Reference: Detroit River International Crossing Study

Subject: Comparison of Recommended Design with VE Recommendation I-36

Exhibit 1 – Recommended Plan (from EA Report)

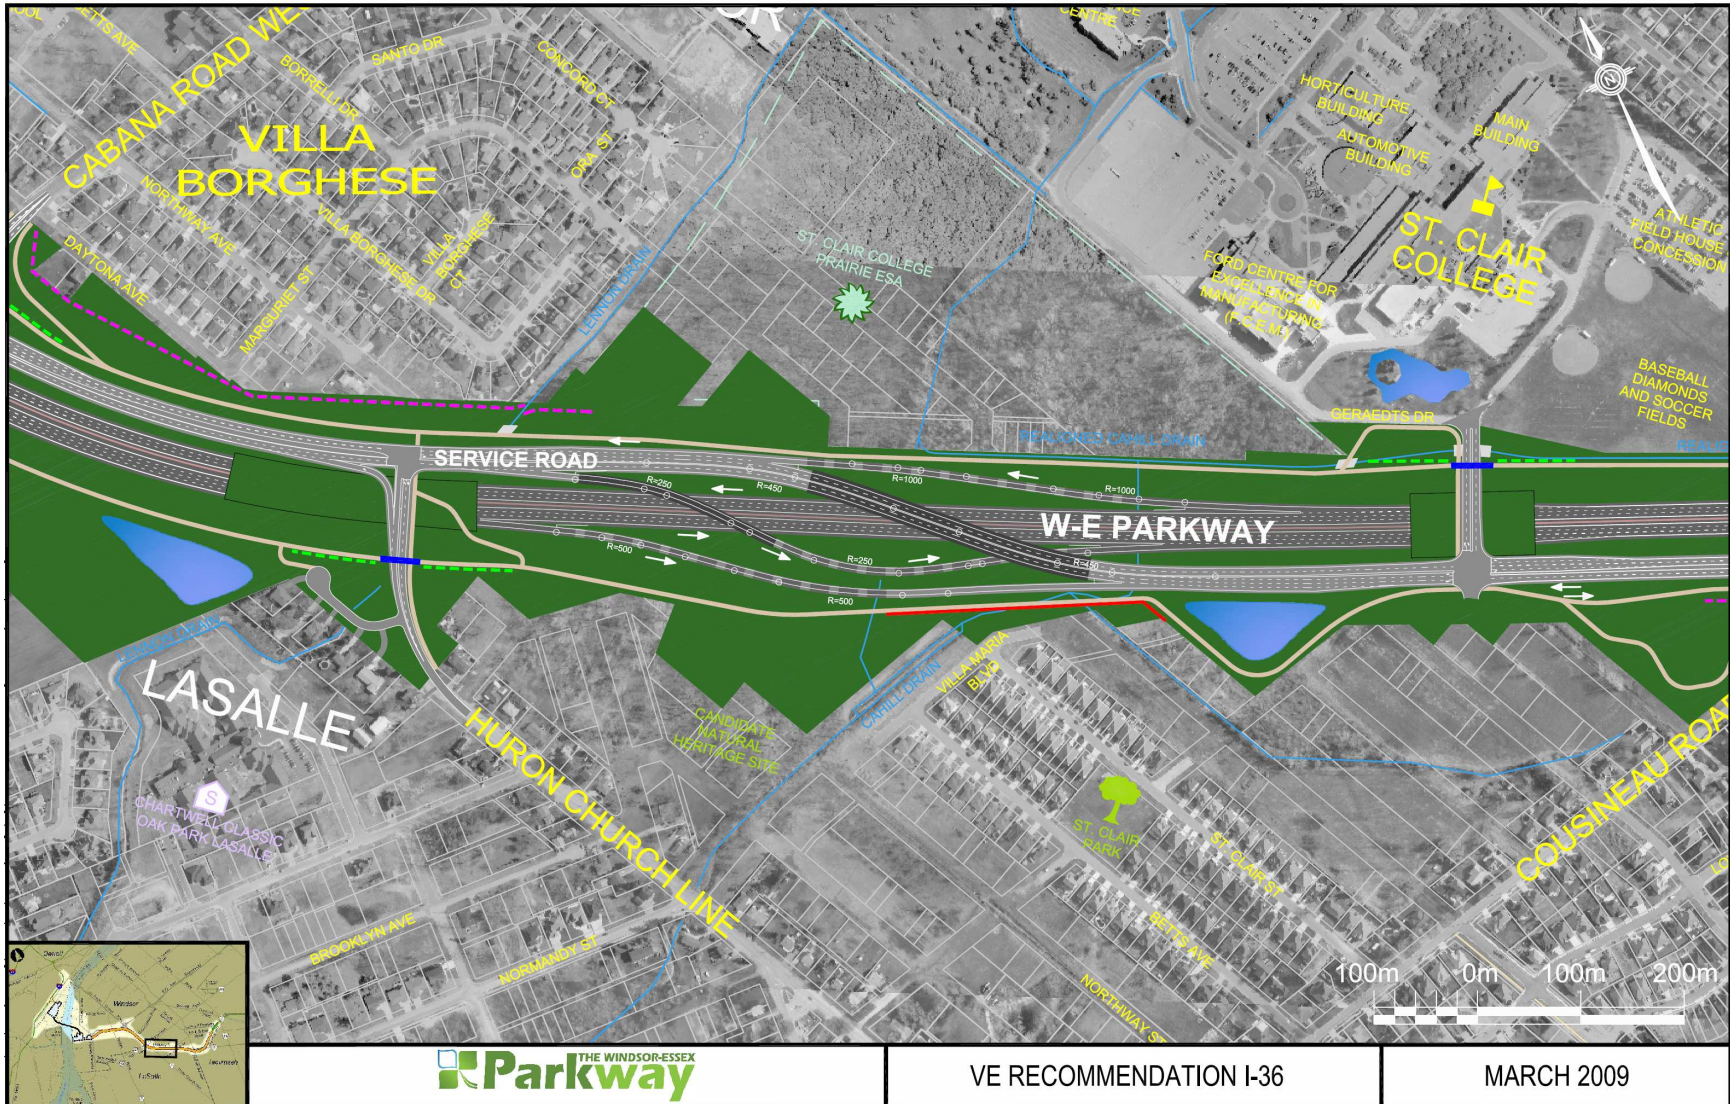
The service road configuration included as part of the Recommended Plan involves a split of the service road immediately east of Huron Church Line. The split service road configuration results in two one-way service roads along this stretch of the corridor, with the one-way service roads crossing over the freeway at structures located approximately 500 m apart. As part of the design, eastbound access to the freeway is provided via an exit ramp located on the left-hand side of the eastbound service road. The configuration included as part of the Recommended Plan is illustrated in **Exhibit 1**.

As part of the Recommended Plan, a siphon is proposed in the vicinity of the existing Cahill Drain crossing, along with a realignment of the Cahill Drain parallel to The Windsor-Essex Parkway. In addition, a fish lock system is being considered in the vicinity of the Cahill Drain. With the Recommended Plan option, the westbound service road structure over the freeway is located almost directly above the existing Cahill Drain, presenting significant difficulties in the design and construction of the fish lock system. With VE Recommendation I-36, both this structure and the westbound freeway off-ramp are shifted to the west, eliminating these constructability issues. In addition, shifting the freeway off-ramp to the west increases the spacing available to provide the siphon, the realigned Cahill Drain, and a potential fish lock

In terms of ramp operations, VE Recommendation I-36 eliminates the left-hand exit ramp from the service road to the eastbound freeway. A right-hand exit is more consistent with typical design standards and driver expectations and provides a significant safety benefit.

For these reasons, it is recommended that VE Recommendation I-36 be carried forward into preliminary design.
